Memorandum

Re: **Cobble Creek Camp (System # 29089, File # 9971)**

This memo is written in response to comments provided by Camron Harry from the Division of Drinking Water (DDW), regarding the Cobble Creek RCMP Water System Improvements project in Weber County, UT.

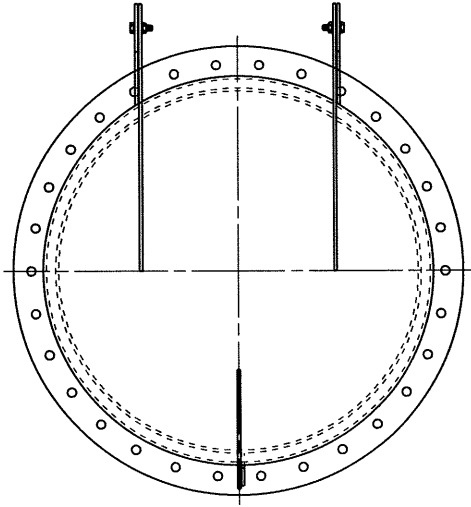
4. R309-520-7(1)(f) Contact Time calculations need to be provided

Response: Currently this water system is not under the influence of surface water, but the camp has had historical issues with positive bacteria tests. In order to address the dated nature of the camp's water system and source, the spring is being completely rehabilitated and an entire new water distribution system put into place. We believe that installation of these two components will provide the needed protection against bacteria contamination. However, in order to deliver additional protection, a disinfection system is provided.

The peak instantaneous demand used for pressure calculations is 47 gpm, which is based on the IPC fixture count calculations. However, we have used 20 gpm which we feel is a more realistic peak flow to use for the CT calculations. Based on the system configuration and flow rate, nearly 5-log removal is achieved. CT calculations are attached, using the Utah Disinfection Profile Calculator.

XERXES [®]		CORPORATION	
DRN	DATE	DR. SIZE	DR. NUMBER
DAG	9-15-09	C	635-526
CHK'D	DATE	30" DIA MANWAY EXTENSION	
STD'S	DATE	HINGED & LOCKABLE TOP	
APPR'D	DATE	STATE OF IDAHO, STANDARD	
SCALE:	1/8	NEXT ASS'Y: -	
			SHT 1 OF 1

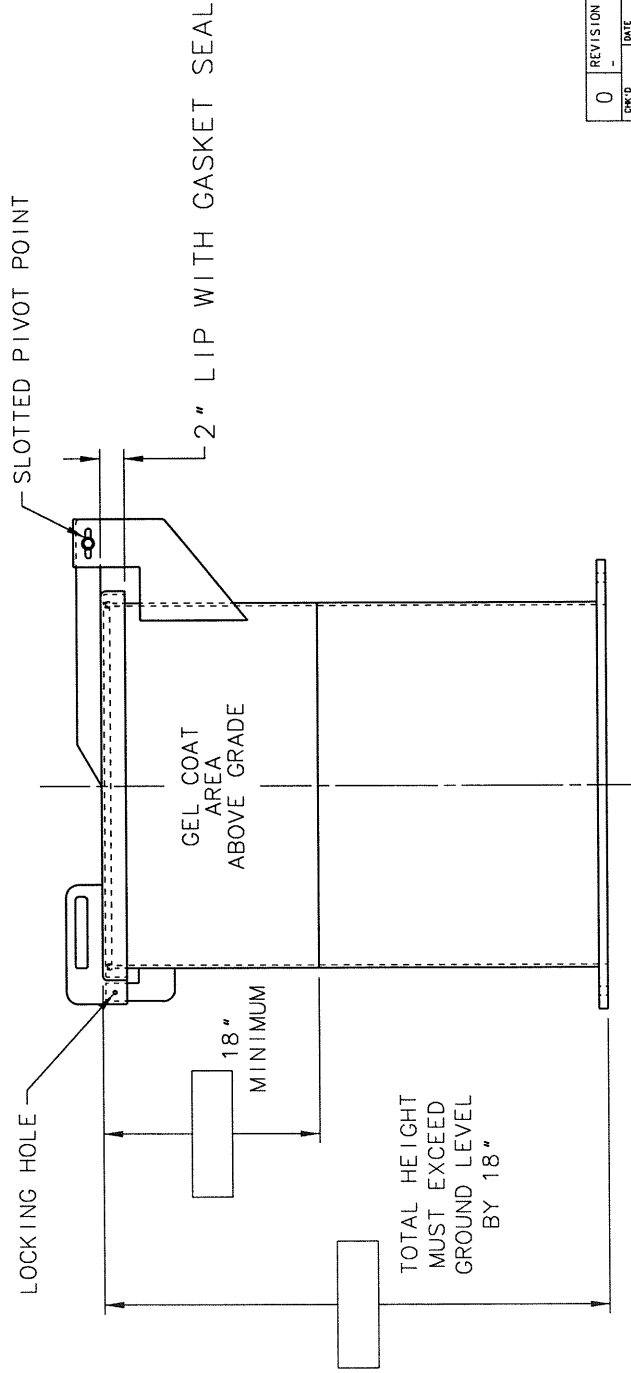
3. R309-545-14 No tank hatch detail, Specification 05 53 00 addresses hatches but not the state requirements (height, shoebox lid, or locking device)

Response: The tank hatch typically provided by Xerxes meets the requirements of this rule. Refer to the attached detail from the manufacturer.
